CALIFORNIA COASTAL COMMISSION

**W9c****STAFF REPORT: REGULAR CALENDAR****APPLICATION NUMBER:** 5-03-073**RECORD PACKET COPY****APPLICANT:** Lucia Ruta **AGENT:** Fred Cravea, Architect**PROJECT LOCATION:** 2508 Ocean Avenue, Venice, City of Los Angeles.

PROJECT DESCRIPTION: Construction of a three-story, 35-foot high (including roof access structure), 852 square foot second residential unit on a 2,617 square foot lot with an existing one-story single family residence. Two parking spaces, provided in the ground floor garage of the proposed building, would serve the resulting two residential units.

EXHIBIT # 3
PAGE 1 OF 1

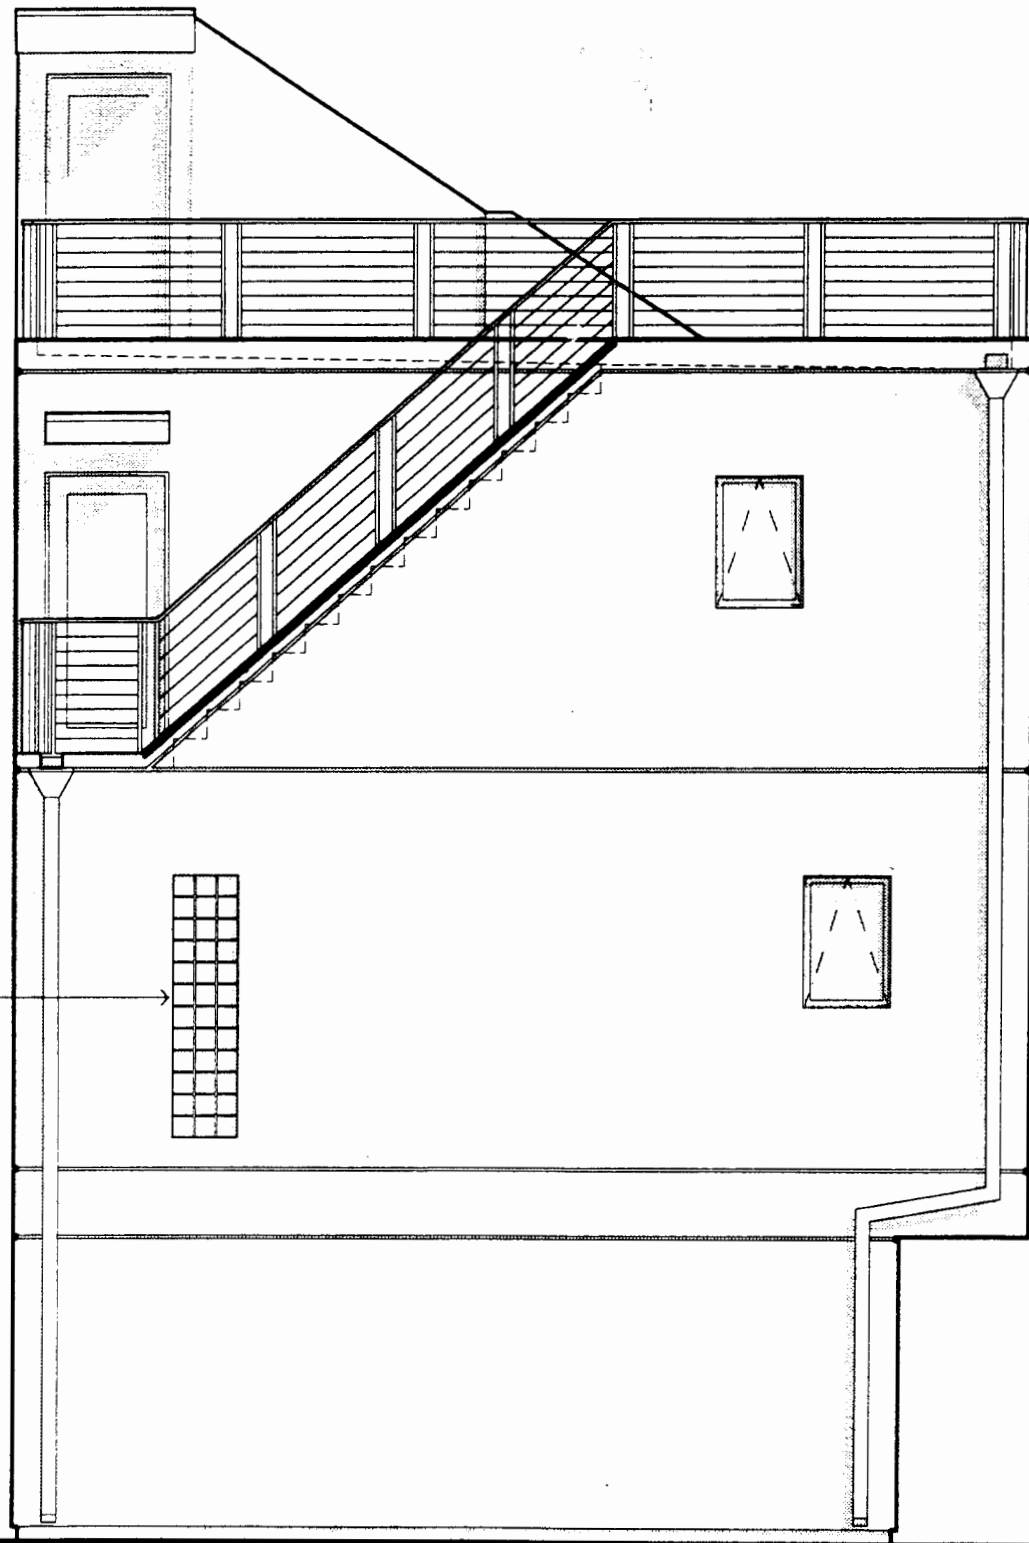
The project site is a 29-foot wide lot with an existing on-site parking area located on the rear portion of the site next to the alley (Exhibit #3). An existing curb cut and gate allow for vehicles to access the rear yard from the rear alley (Ocean Court). The applicant asserts that no on-site parking is required for the 1915 single family residence, and that the unpaved rear yard is not used as a parking area for the existing single family residence. A site visit by Commission staff, however, confirmed the presence of a parked automobile in the rear yard. The applicant asserts that the vehicle was merely being stored in the yard while she was traveling out of town. In any case, the site does currently provide an on-site parking area for the existing residential use, albeit an unpaved area.

Therefore, there is at least one existing parking space on the site. The proposed three-story residential unit would displace the existing on-site parking supply. The ground floor of the proposed structure is a two-car garage. No other parking supply is being proposed. The proposed two-car garage is not an adequate parking supply for two residential units, and would

not provide the additional parking necessary to maintain and enhance public access to the coast as required by Section 30252 of the Coastal Act. Therefore, the coastal development permit application is denied. In order to conform to the parking requirements of the Coastal Act and the certified Venice LUP, the applicant would have to provide at least two on-site parking spaces for the proposed second residential unit, in addition to the current on-site parking supply.

EXHIBIT # 4
PAGE 1 OF 1

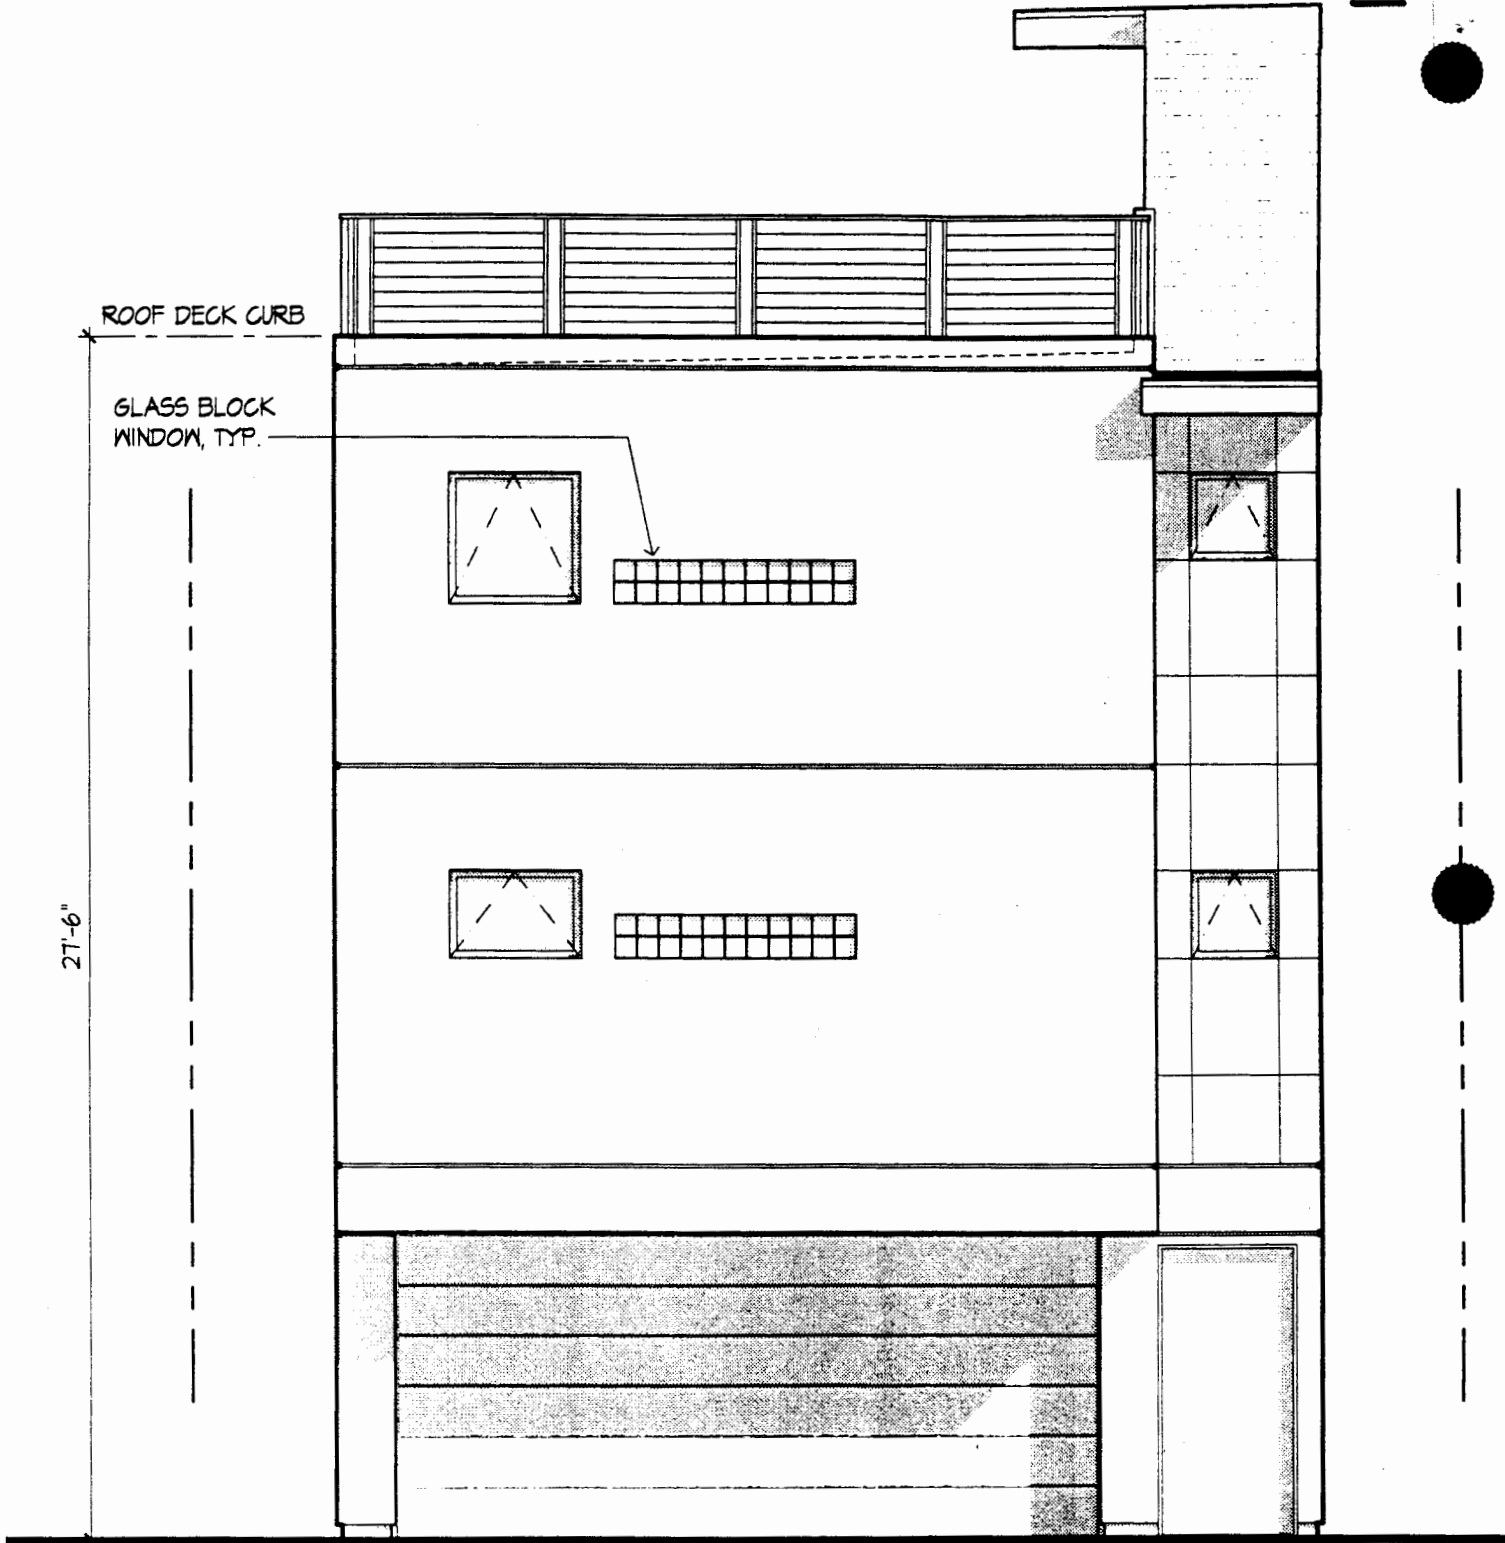
The City Planning Department granted the applicant's request to exceed the building height limit when it approved the Project Permit (Case No. ZA 2002-4354). The roof and roof deck of the proposed structure would reach 27.5 feet above the elevation of Ocean Avenue (Exhibit #4). A proposed roof access structure would extend up to 35 feet in height. The height limit set forth in the certified Venice LUP is 25 feet for flat-roofed buildings, and thirty feet for buildings with varied rooflines. The proposed roof deck exceeds the applicable 25-foot height limit by 2.5 feet. The house next door at 2504 Ocean Avenue was approved as a 25-foot high single family residence [Coastal Development Permit 5-02-026-W (Lavery)]. Staff is recommending that the Commission deny the permit application because the height of the proposed structure would negatively affect the character and scenic and visual qualities of the community in violation of Sections 30251 and 30253 of the Coastal Act.

The proposed project does not conform to the Southeast Venice area height limit set forth in LUP Policy I.A.7.d above because it proposes a flat roof and an observation deck at the 27.5-foot elevation (above Ocean Avenue), 2.5 feet over the flat roof height limit (Exhibit #4). The proposed 27.5-foot high observation deck would tower over the neighboring buildings in this primarily one and two-story neighborhood. The density issue is discussed in the next section of the staff report.
